EL PASO COUNTY FILE NO. PCD # SF-20-014

CLAREMONT BUSINESS PARK 2 FILING NO. 1	
NOTE & DETAIL SHEET	
PROJECT NO. 44-037	FILE: \dwg\Const\DWG\Streets\Plans\S02.dwg
DESIGNED BY: GW	DATE: 08/19/2020
DRAWN BY: CLP	SCALE: N/A
CHECKED BY: VAS	SHEET 2 OF 12
S102

CLAREMONT BUSINESS PARK 2 FILING NO. 1

STREET IMPROVEMENT PLANS

TYPICAL CURB AND GUTTER DETAIL (SD 2-20C)

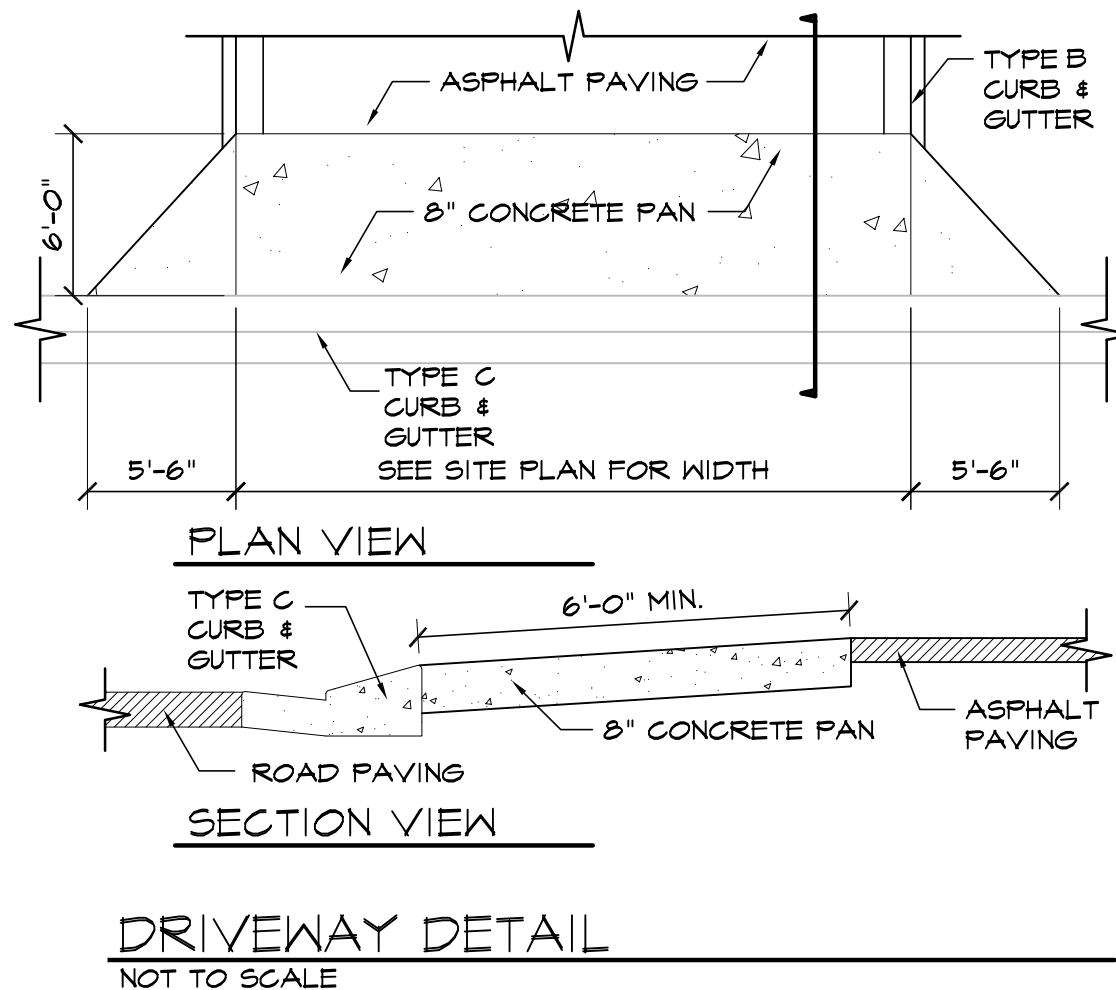
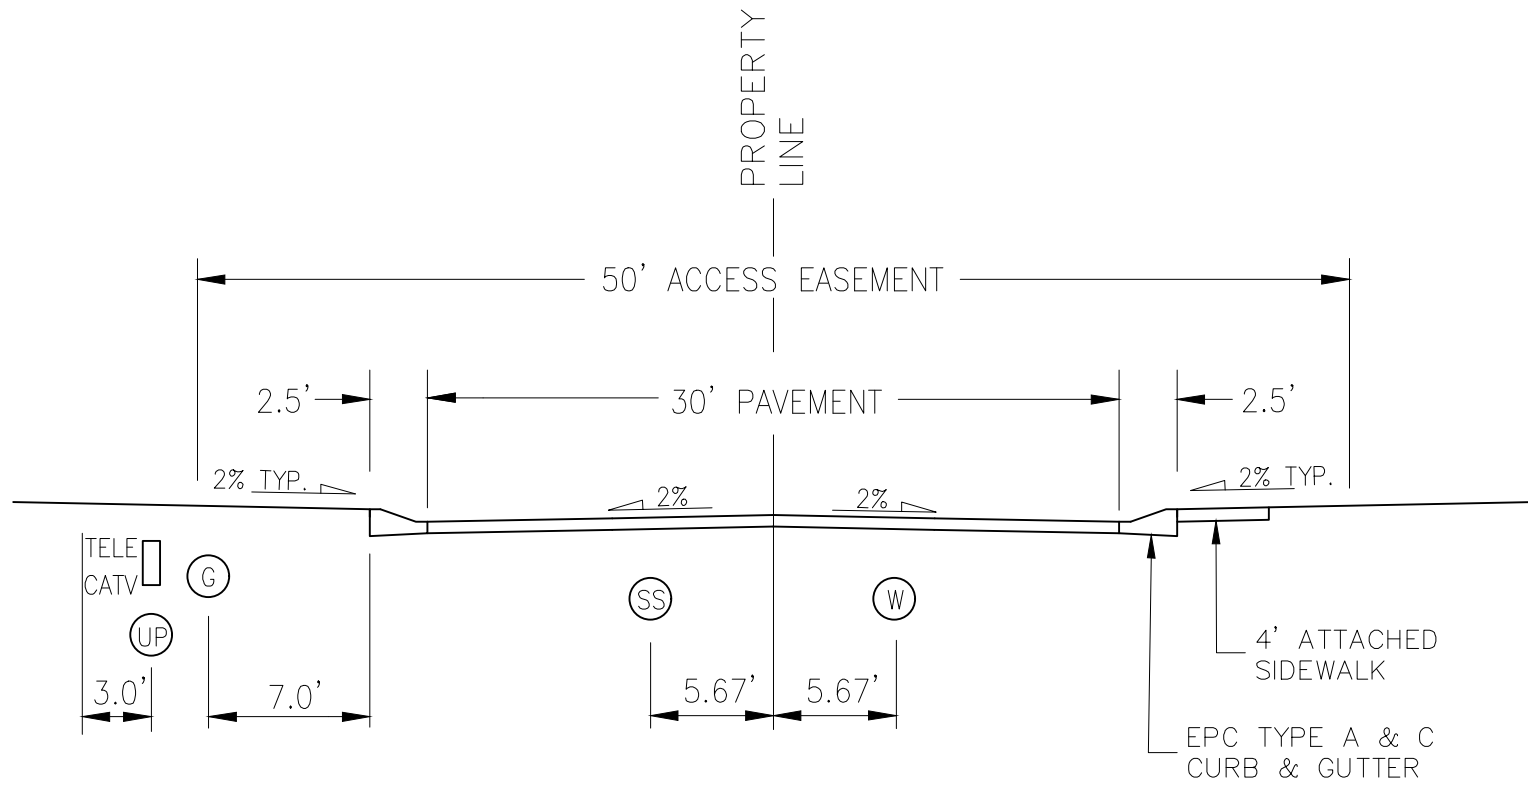
Please use the latest detail that was approved by the BoCC with the addition of Chapter 6 to the ECM. I have attached a PDF of Ch6 which includes this detail.

SI03

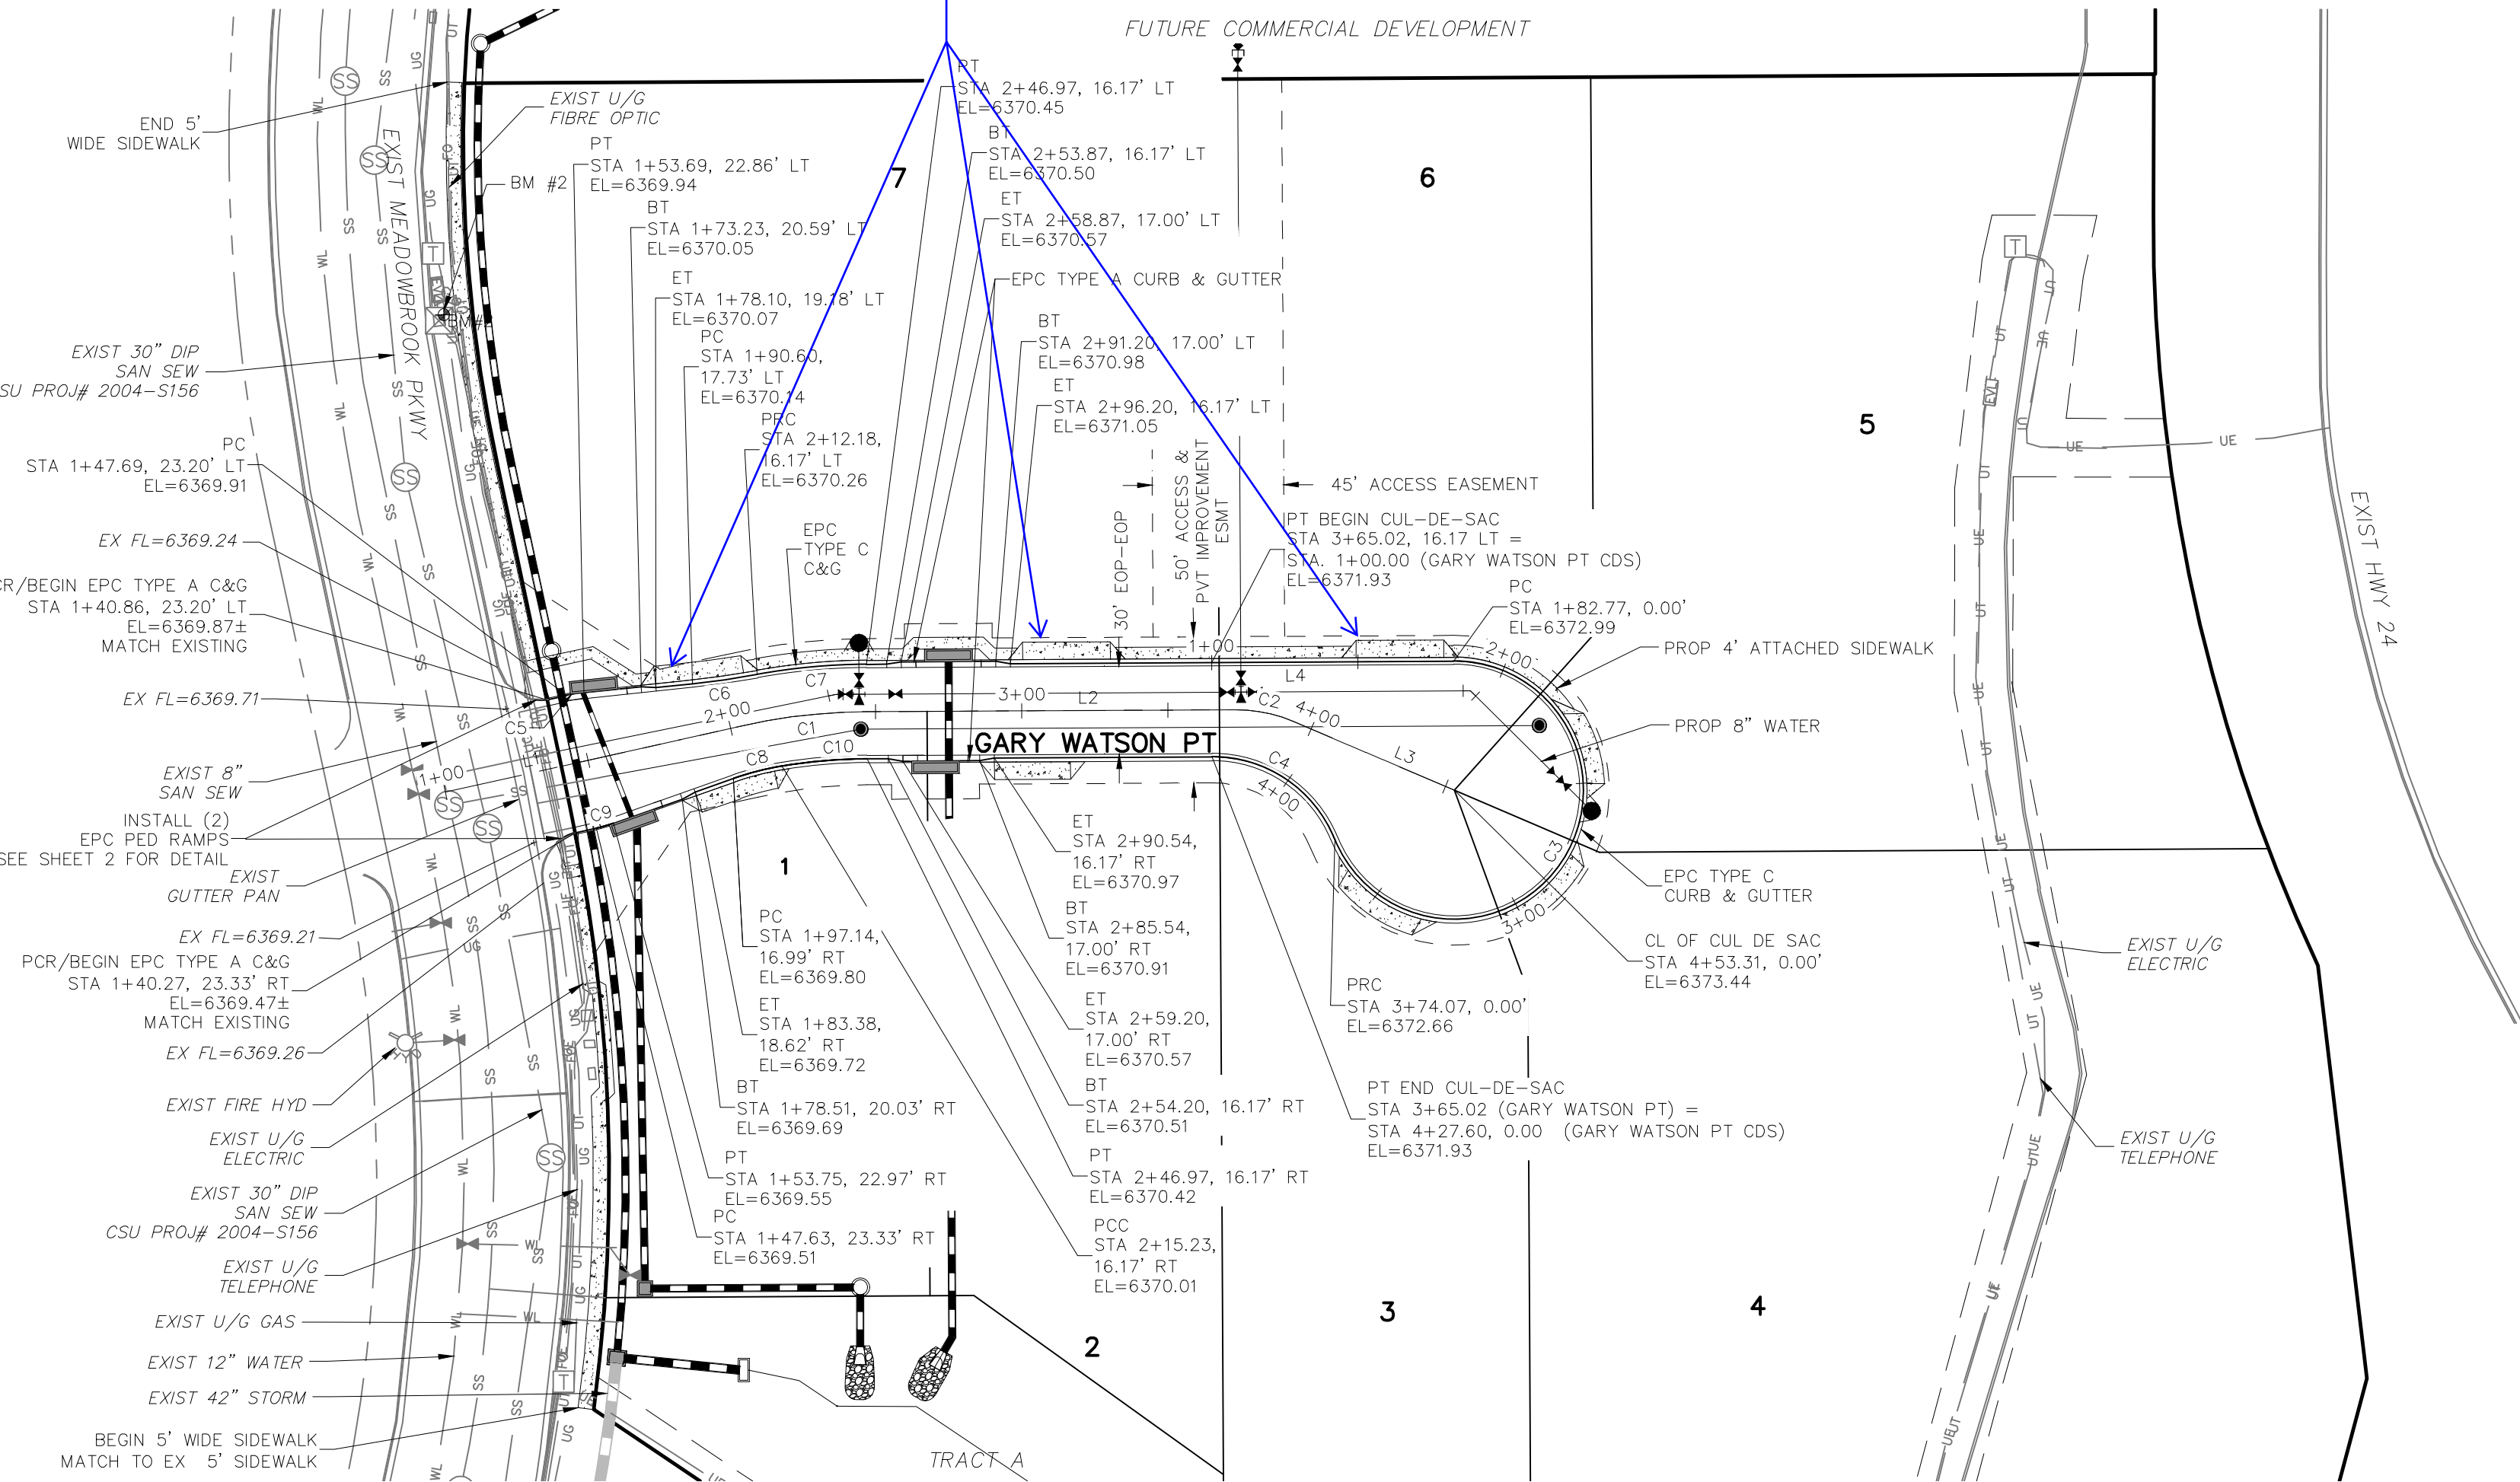
Revise the sidewalk to go around the driveway. The sidewalk as currently shown would not meet ADA standards. Refer to county standard detail SD\_2-24

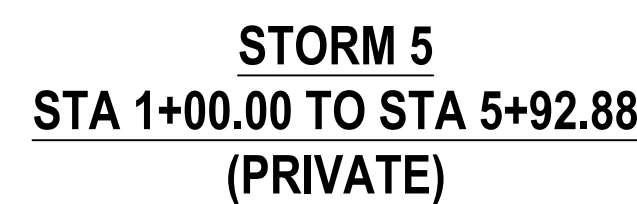
Review 1: Identify the vertical scale  
Review 2: Unresolved.  
indicate the vertical scale for the profiles below

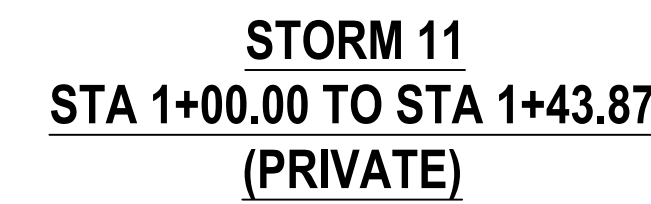
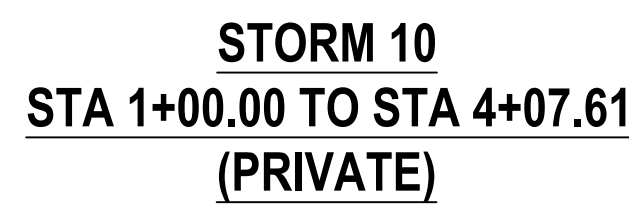
Review 1: Identify the vertical scale  
Review 2: Unresolved.  
indicate the vertical scale for the profiles below
